DESCRIPTIVE REPORT

~~Topographic~~ } Sheet No. **H-6350**  
Hydrographic }

Southern coast of Cape Cod

REVIEW OF HYDROGRAPHIC SURVEY NO. 6350 (1938) FIELD NO. 6350

Overlay tracing showing sounding lines in  
immediate vicinity of 40 and 44 foot depths  
Scale 1-20,000

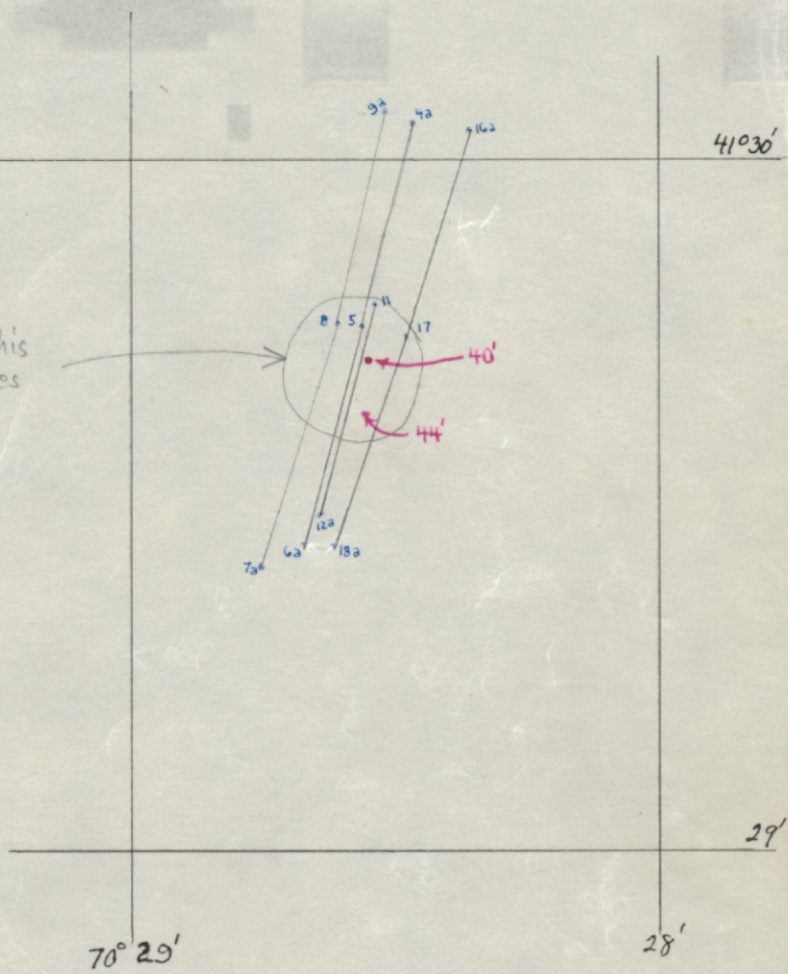
1. A close system of lines failed to verify the 40 and 44 foot spots at Lat.  $41^{\circ} 29'.7$ , Long.  $70^{\circ} 28'.55$  and Lat.  $41^{\circ} 29'.6$ , Long.  $70^{\circ} 28'.55$ , respectively. A 54 foot sounding was obtained 55 meters north of the 40 and a 64 foot sounding 45 meters NW of the 44. It is recommended that the 40 and 44 be deleted and the soundings as shown on the current development substituted.

1. Two photostats of H-6350 (1938) before application of additional work
  2. Section of current chart No. 1269
  3. Tracing accompanying comments in Par. 1a
1. 40- and 44-ft. soundings in depths of 62-72 feet;  
Lat. 41°29.7'; Long. 70°28.56'
    - a. 40-ft. depth

Investigation of the 40 originating with the 1938 work (H-6350) reveals a lump with a least depth of 54 feet.

Development of the lump on the present survey, which rises about 8 feet off the bottom, is confirmation of shoaler depths existing in this vicinity and therefore tends to lend validity to the original sounding. Since the sounding records reveal no evidence of drift sounding, and the present smooth plotted sounding line spacing consists of two lines spaced 10 meters apart, passing just west of the 40 whereas the nearest adjacent lines are 70 meters distant (see tracing in D. R.), the development is accordingly not definitely conclusive. In the interests of safety, it is considered advisable to retain the 40.

b. 44-ft. depth

Two sounding lines spaced 80 meters apart pass on either side of the 44. This spacing is approximately equal to the sounding interval on which the 44 was originally obtained. This development reveals that the 44, if authentic, has a small base of not over 80 meters in extent. In the absence of drift sounding or a closer line spacing, it is advisable in the interests of safety to retain the 44.

Retain  
See Rev. Band

Section of Chart 1209  
 Scale 1-80,000  
 EA: Aug. 18, 1942

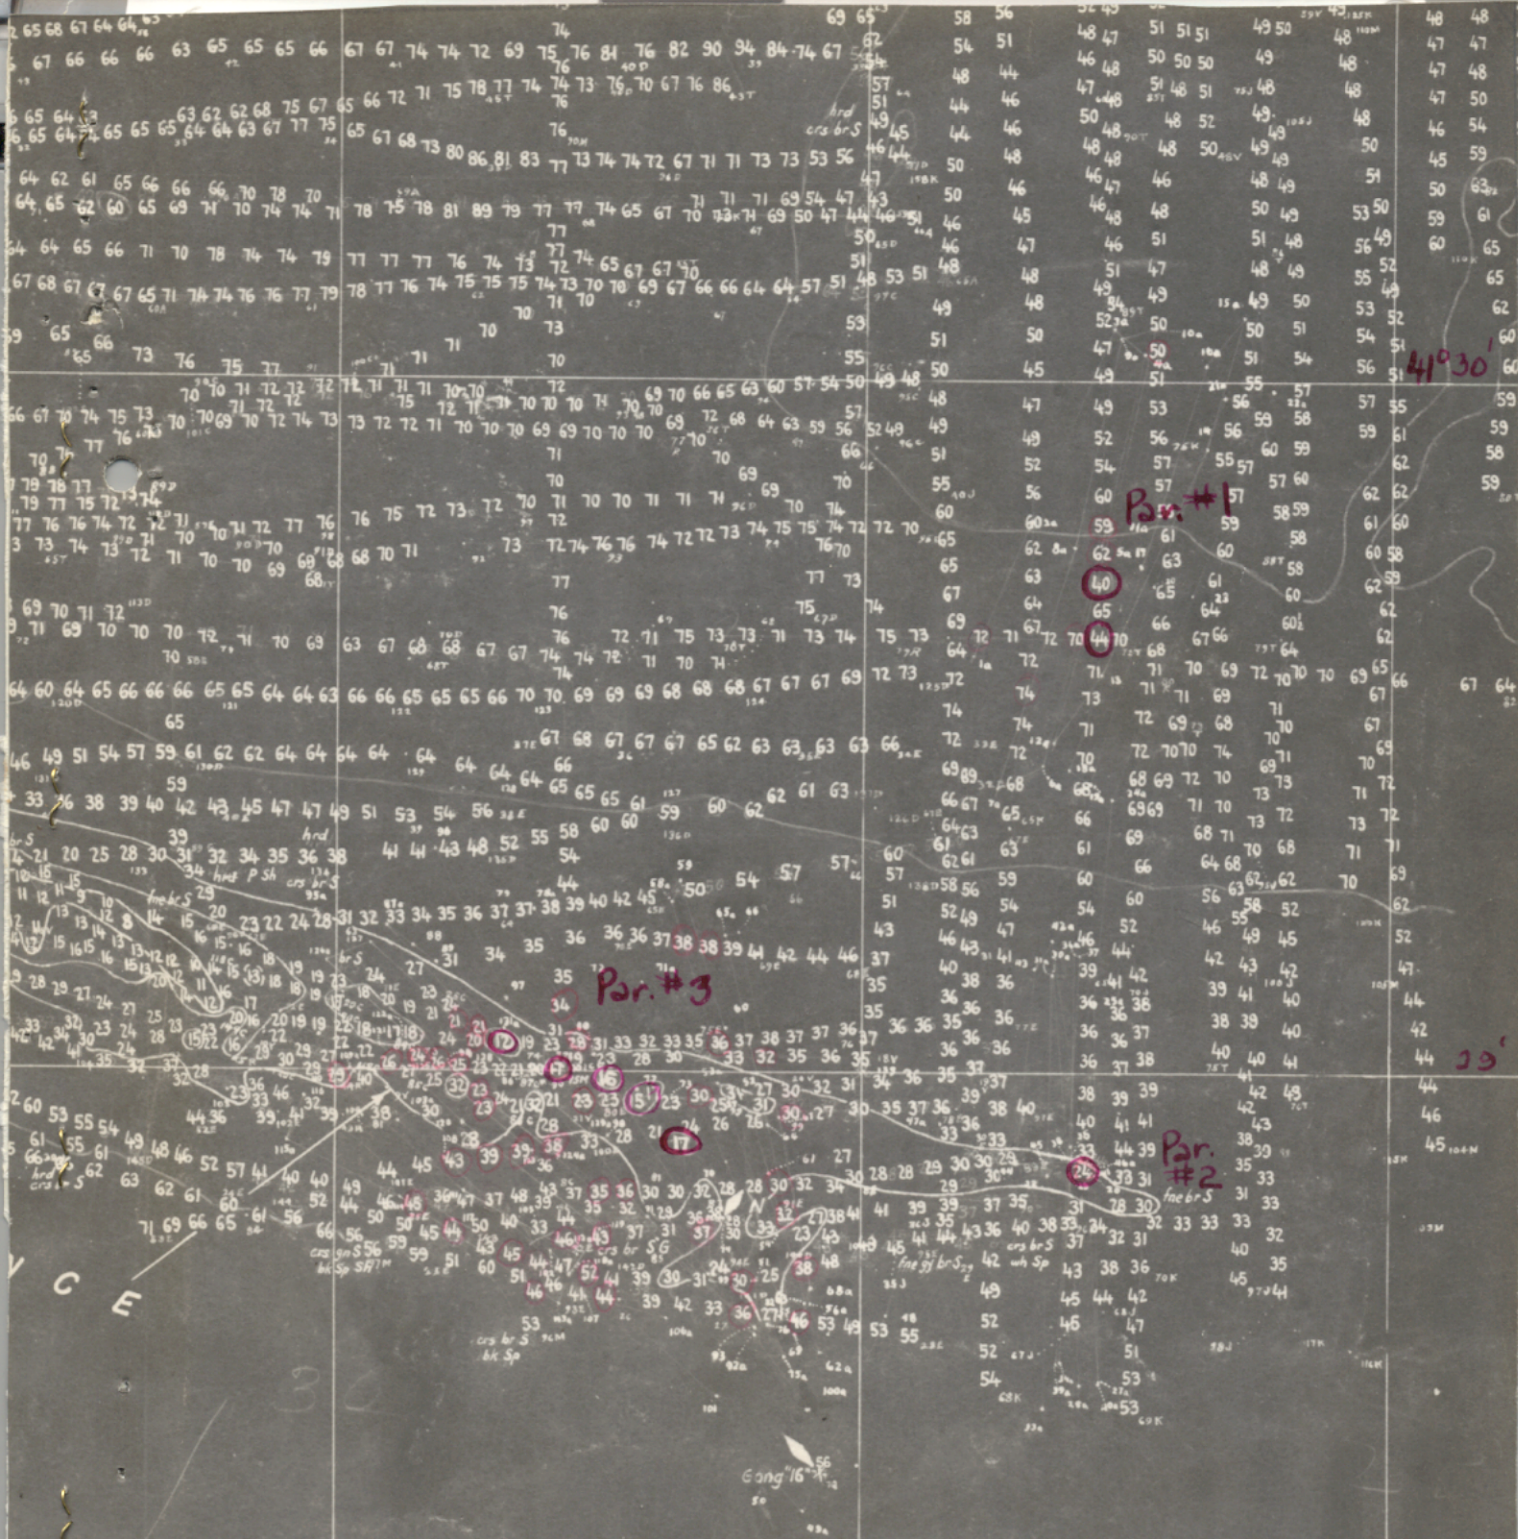
Par. #1

Par. #3

Par. #2

Copy of H-6350(1938) before plotting of Add'l Wk.  
Scale 1-20,000

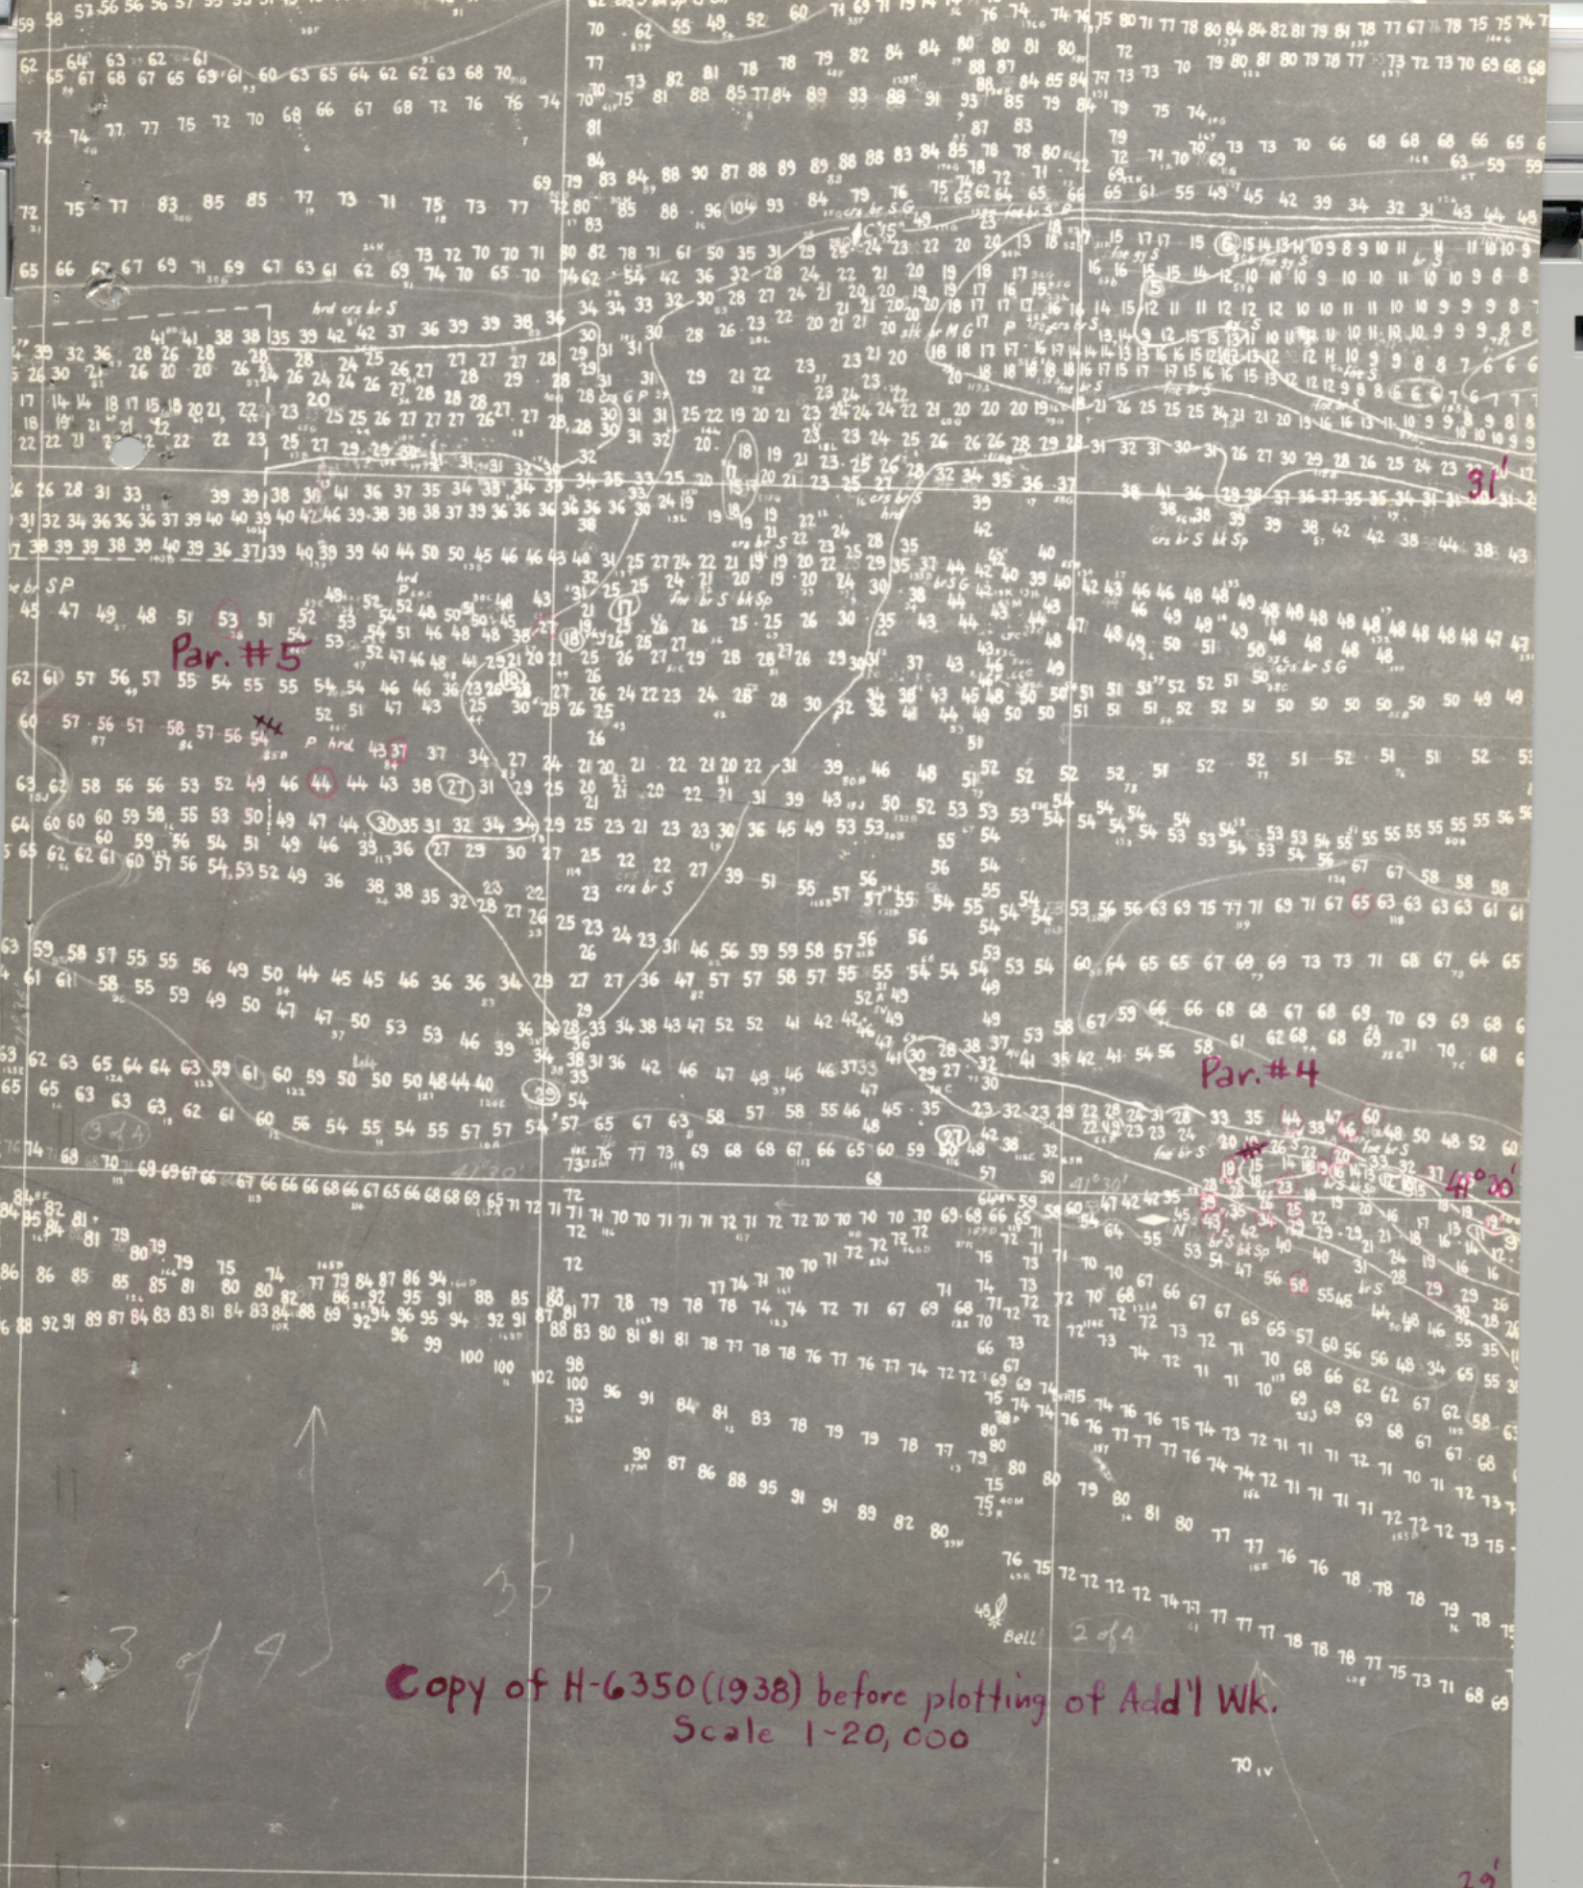
2. The 24 foot sounding at Lat.  $41^{\circ} 28'.84$ , Long.  $70^{\circ} 28'.57$  was substantially verified by obtaining a 22 foot sounding 45 meters NNE of the spot, and a 26 foot sounding just SE of the position. It is recommended that the 22 foot sounding be charted in lieu of the old 24.

The 24 was confirmed, a least depth of 22 feet being found in the same spot. The 22 now replaces the 24 on the smooth sheet. The 30-ft. curve outlining the easterly extension of Hedge Fence Shoal is now better developed.
